PotlatchDeltic

Subject: Draft version of Air Emissions Permit No. 05700002-101, PotlatchDeltic Bemidji Lumbermill, Public Comments

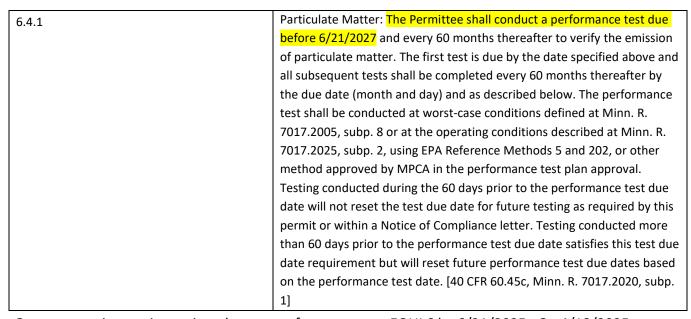
We would like to request the use of an alternative span value including the range of 30-40% for daily calibration drift tests. After speaking with our contractor, this sounds appropriate for an opacity monitor that includes a 20% opacity limit (i.e., opacities of 60-80% are already well beyond our limit).
